ADDENDUM #3

Project	Holy Family Catholic Elementary School	Project No.	2325
Location	1420 Grosvenor Street, Oakville, ON	Date of Issue	2024 04 09
Owner	Halton Catholic District School Board	File	2325/7.1.3

RE: Holy Family Catholic Elementary School
Renovations
Oakville, ON

ADDENDUM 02

No.	Revisions	Date
1	Issued for Coordination	2024-03-08
2	Issued for Coordination	2024-03-11
3	Issued for Bids & Building Permit	2024-03-26
A	Issued for Addendum	2024-04-05

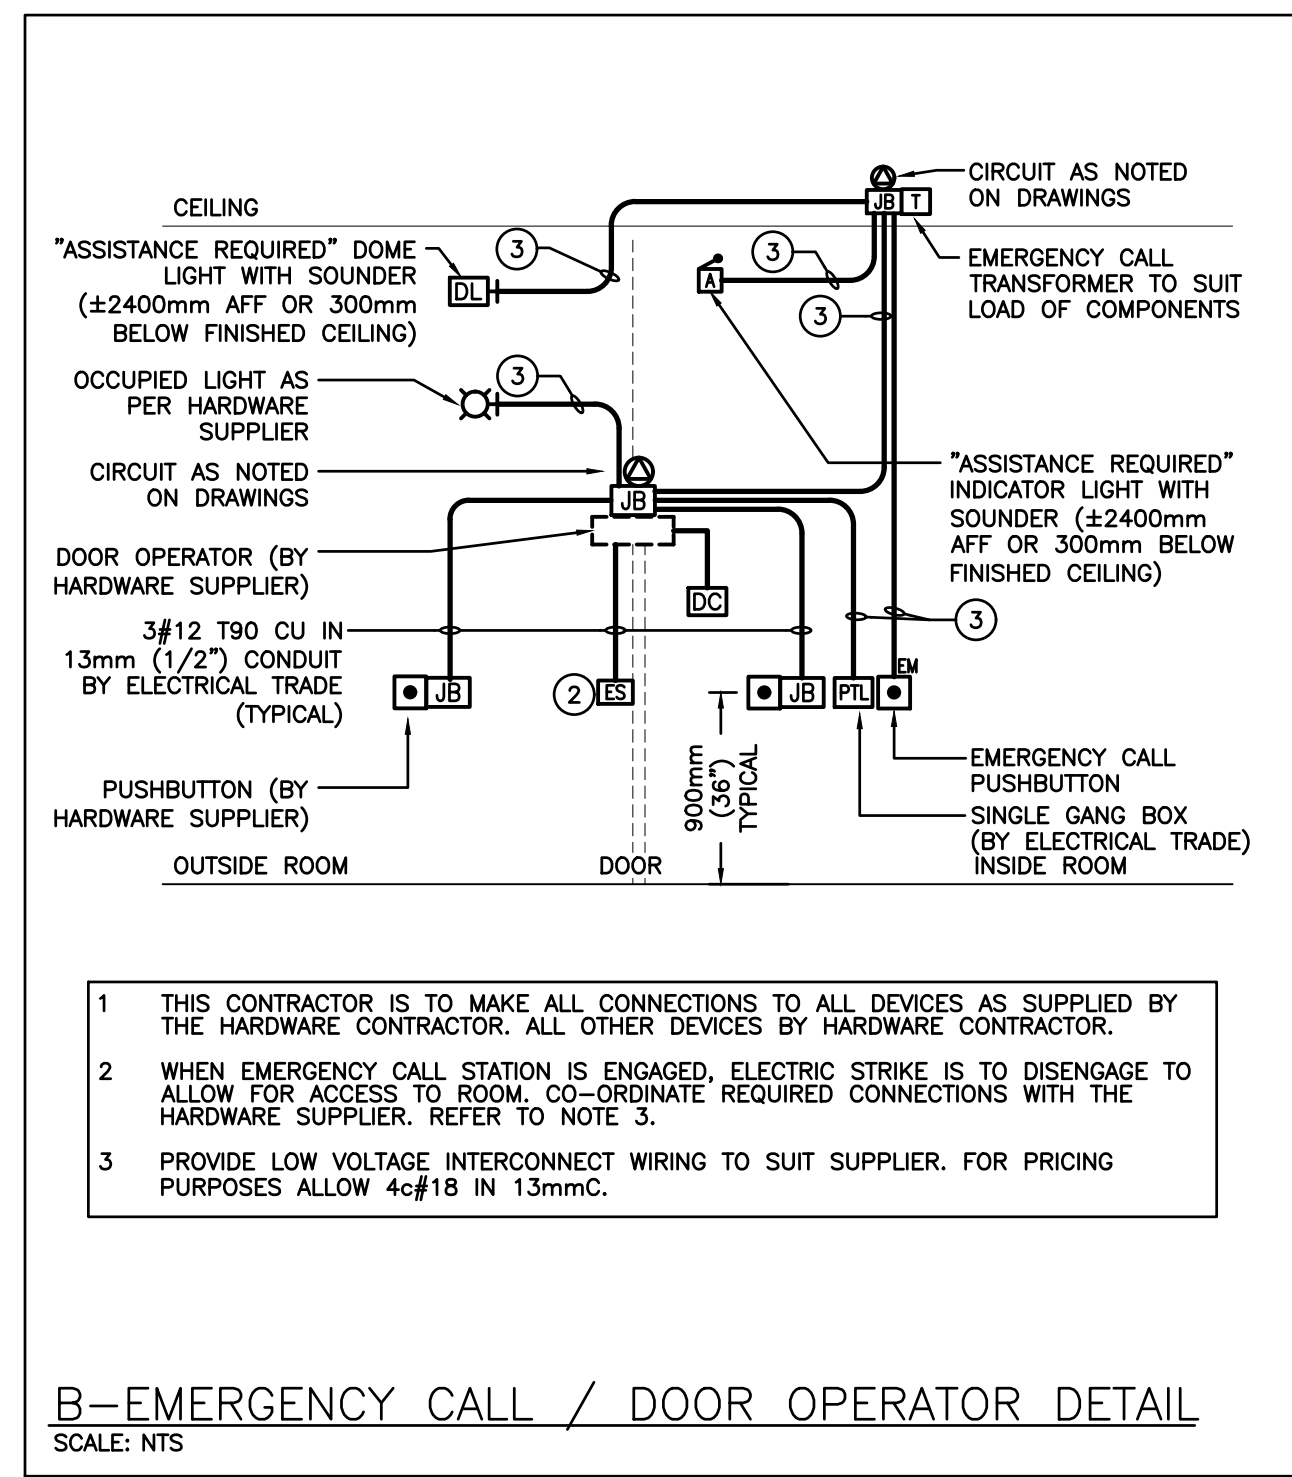
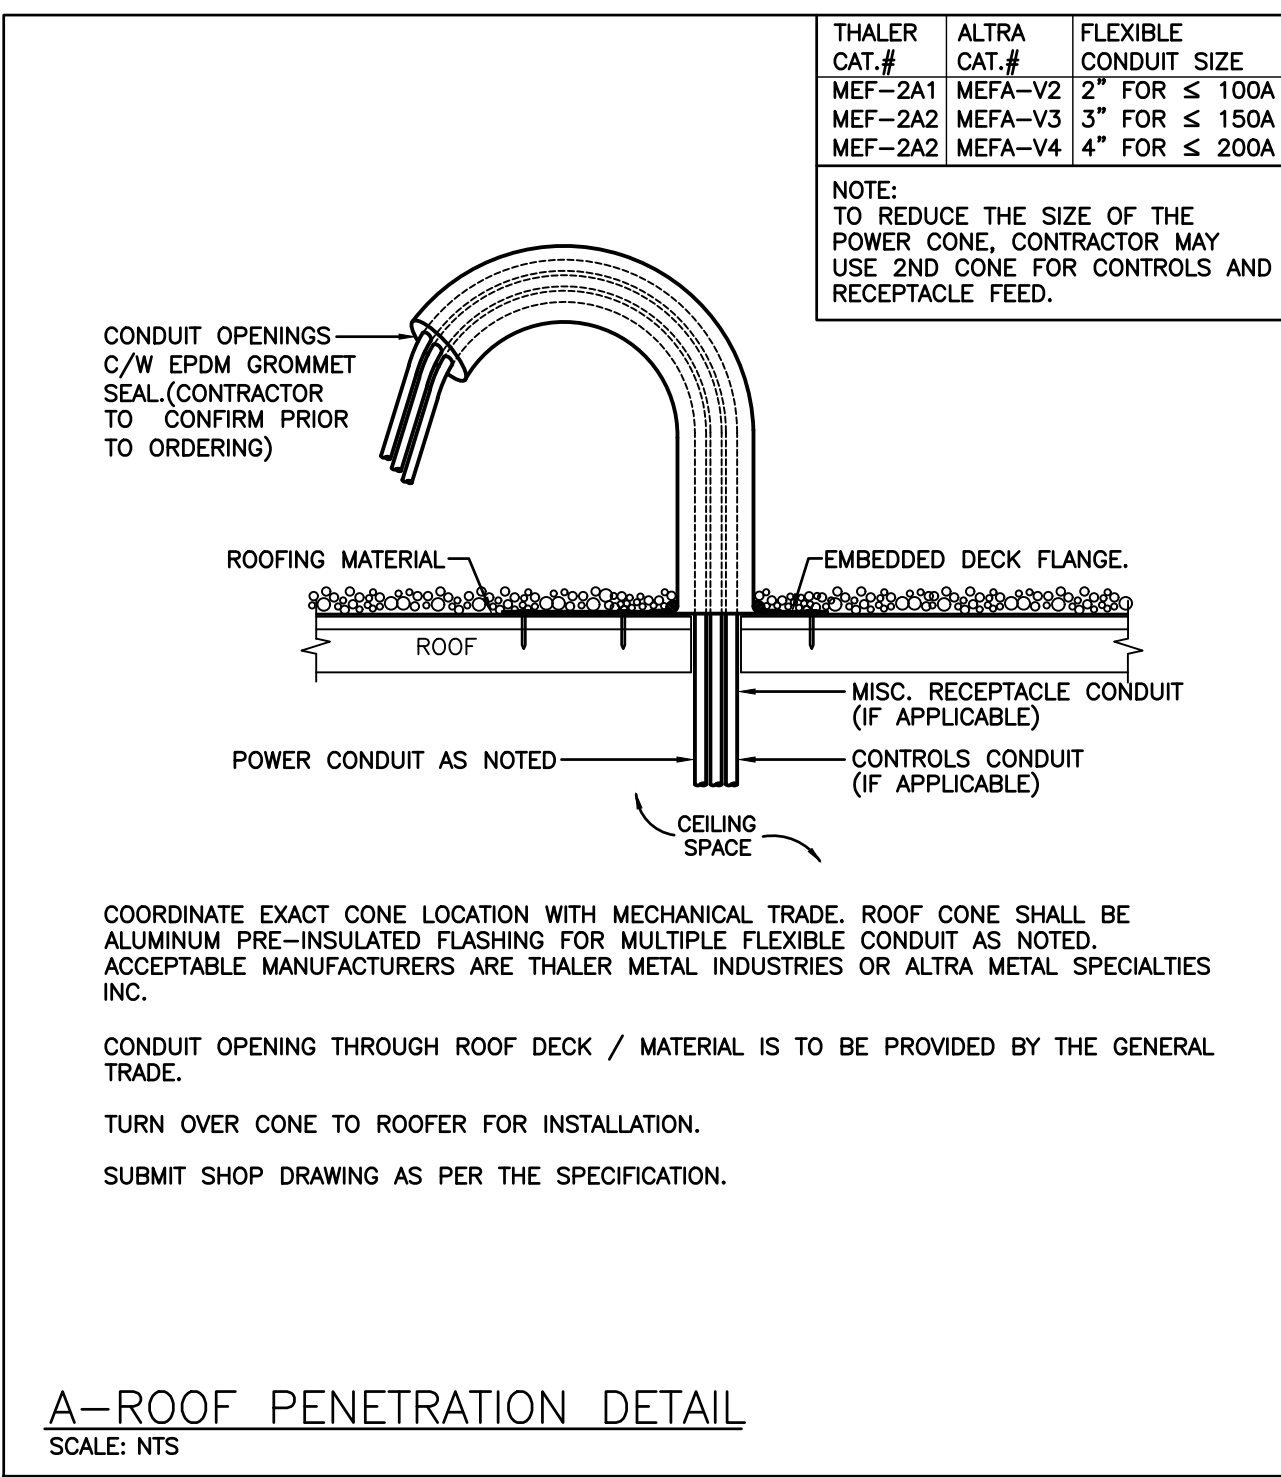
2.0 Reference Attached Reissued Drawing E1.1
.1 Revise notes #2 and #3 as shown.
.2 Remove detail A and B.
.3 Add 'ELECTRICAL SERVICE- SCOPE OF WORK'.

ELECTRICAL SERVICE-SCOPE OF WORK

OAKVILLE HYDRO (UTILITY) WILL PROVIDE THE FOLLOWING WORK. COST WILL BE PART OF THE ALLOWANCE FOR UTILITY WORK AS LISTED IN SPECIFICATIONS

- H1 ISOLATION/MAKE SAFE OF EXISTING SERVICE.
- H2 DISCONNECT, RECONNECT OR SUPPLY AND INSTALL OF PRIMARY FEEDERS.
- H3 PROVIDE NEW TRANSFORMER.
- H4 RECONNECTION OF SECONDARY FEEDERS.

THE ELECTRICAL CONTRACTOR FOR THE BUILDING OWNER (CUSTOMER) SHALL BE RESPONSIBLE FOR THE FOLLOWING:

- C1 REMOVAL AND DISPOSAL OF EXISTING SECONDARY CABLES BETWEEN TRANSFORMER AND SWITCHBOARD.
- C2 TESTING OF EXISTING DUCTS TO ENSURE SUITABILITY FOR RE-USE PER SPECIFIC NOTE 4.
- C3 INSTALLATION OF NEW SECONDARY CABLES IN EXISTING DUCTS.
- C3 GROUNDING AS PER ELECTRICAL CODE. PROVIDE COORDINATION STUDY PER SPECIFICATIONS.
- C4 ALL WORK SHALL MEET UTILITY REQUIREMENTS & INSPECTION. ELECTRICAL CONTRACTOR TO CO-ORDINATE WITH UTILITY PRIOR TO PROCEEDING.

Drawing Title
LIGHT FIXTURE SCHEDULE AND DETAILS

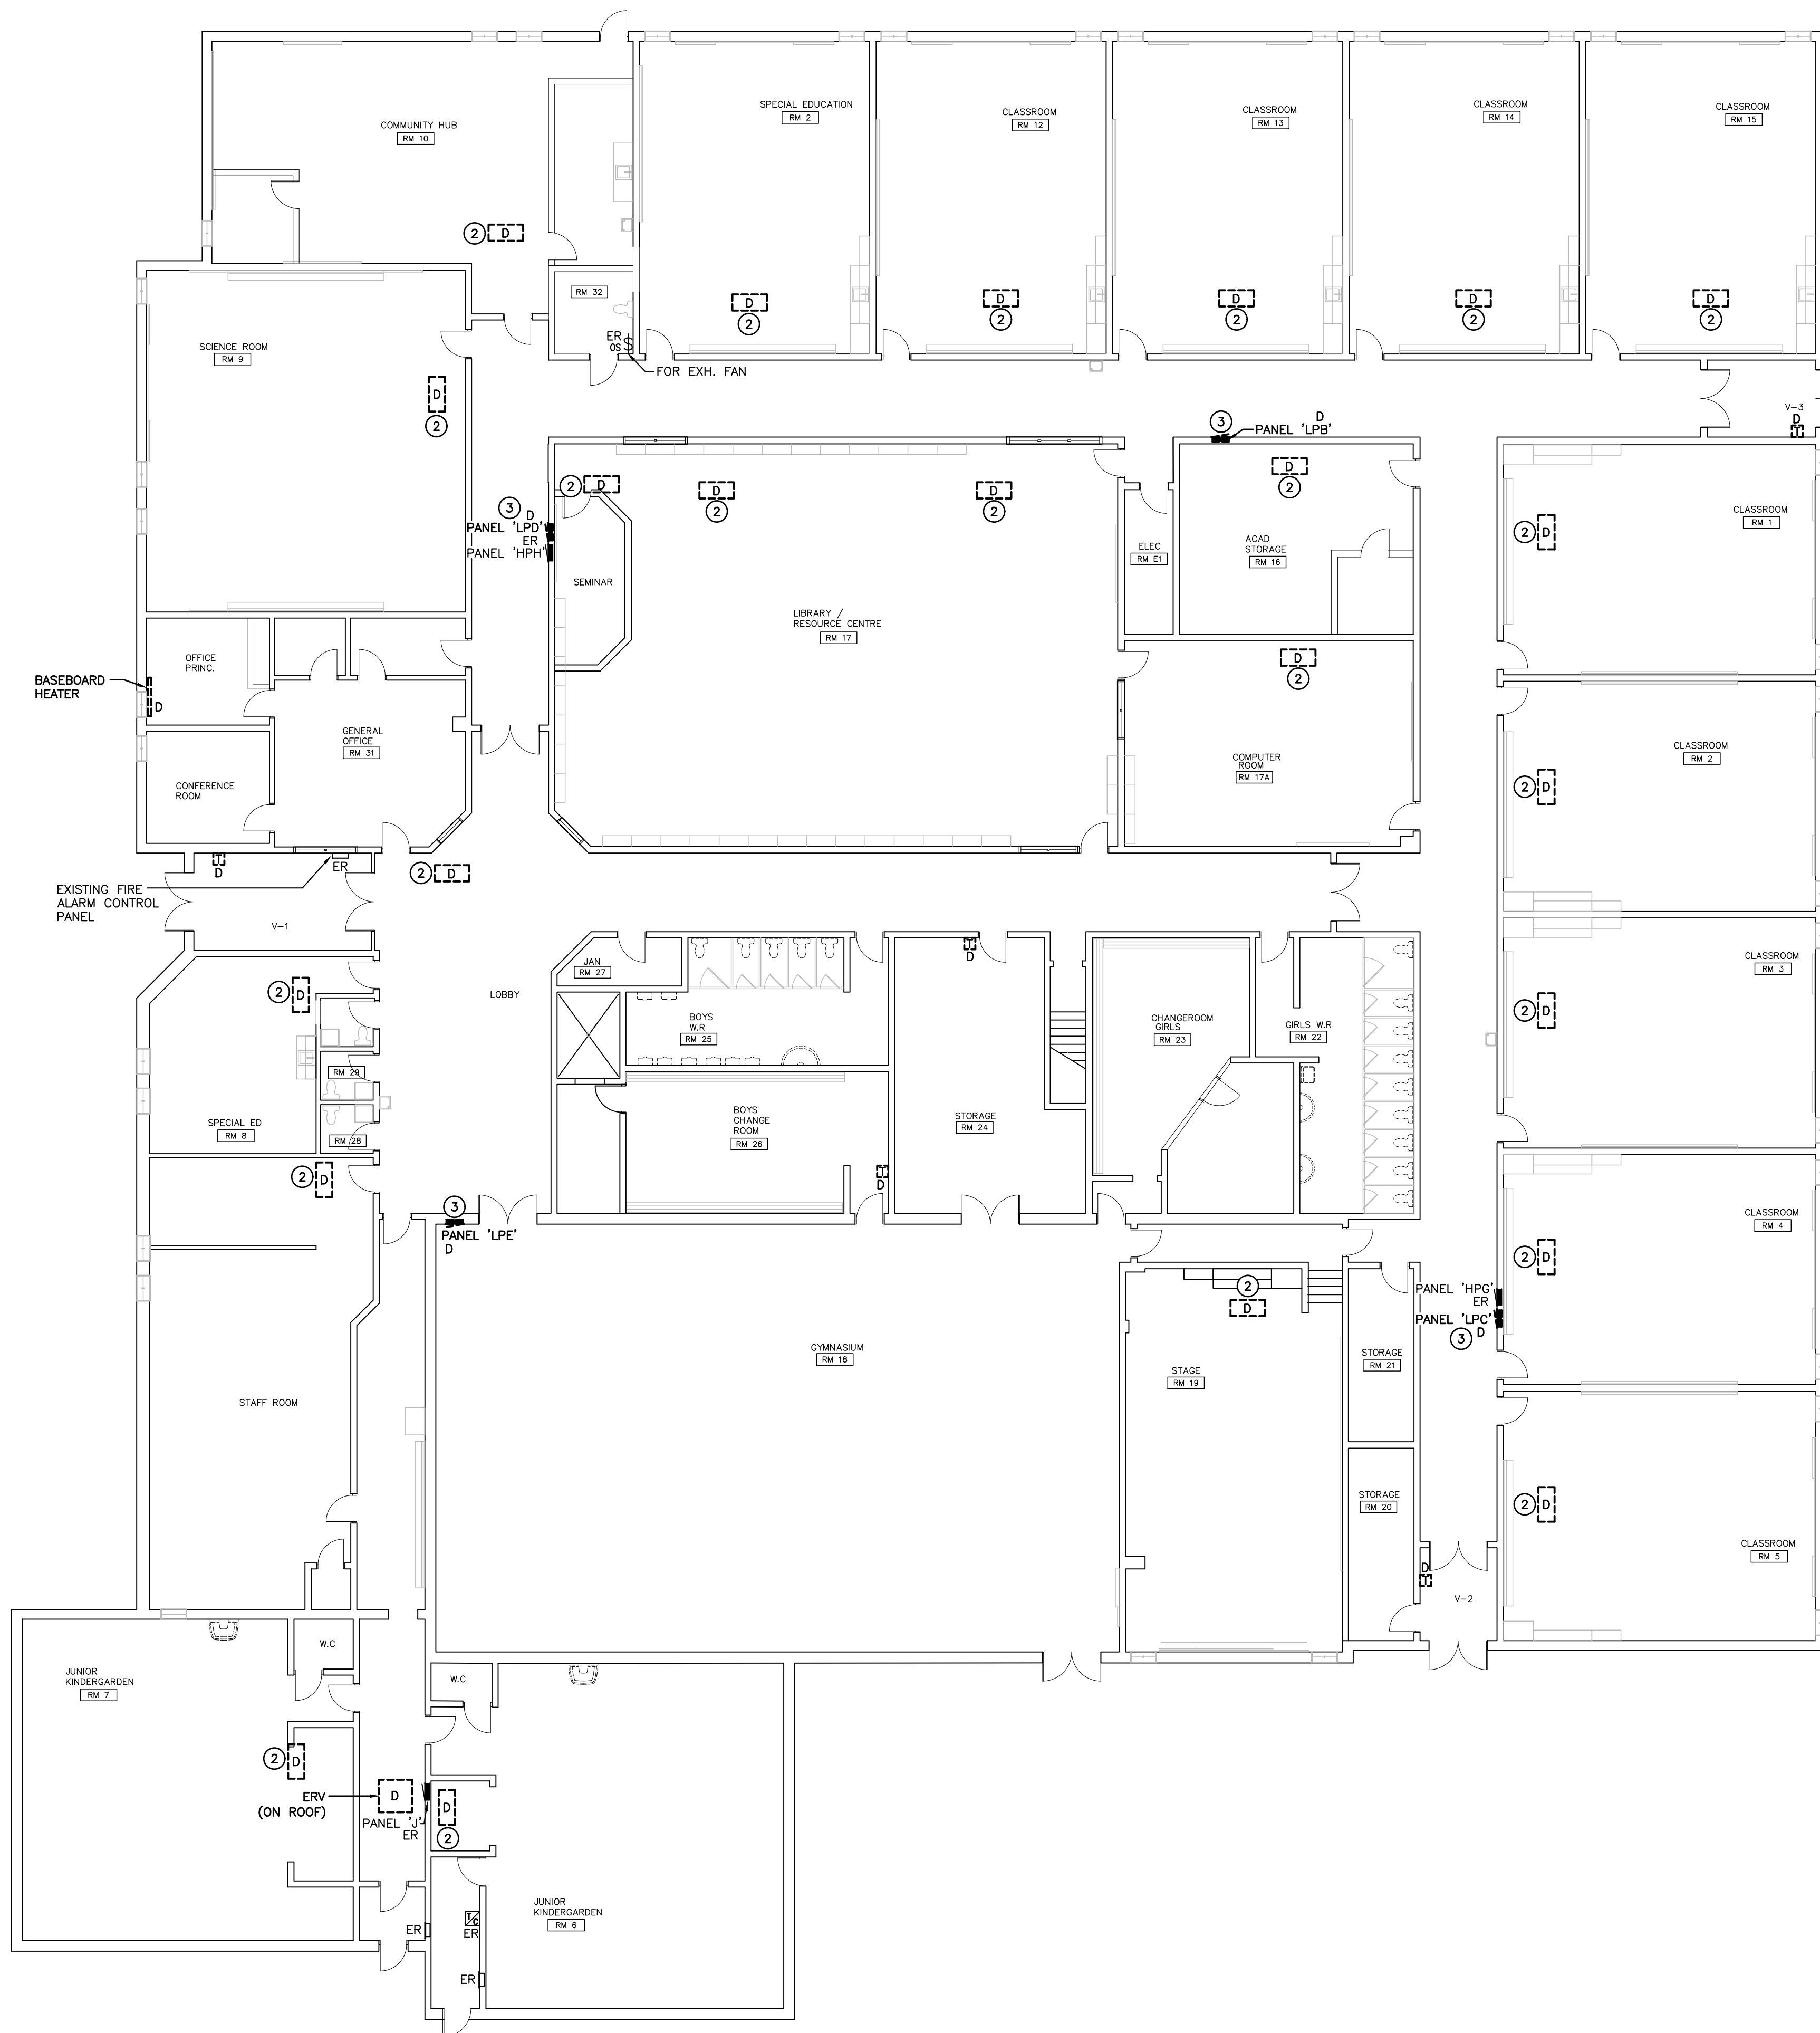
4.0 Reference Attached Reissued Drawing E1.4
.1 Provide lighting control details for 3-button occupancy switch control as shown.
.2 Provide lighting fixture equals for fixture Type 'C' as shown.
.3 Revise light fixture schedule Types A, A1, A2, B, B1, and C to show approved alternate.
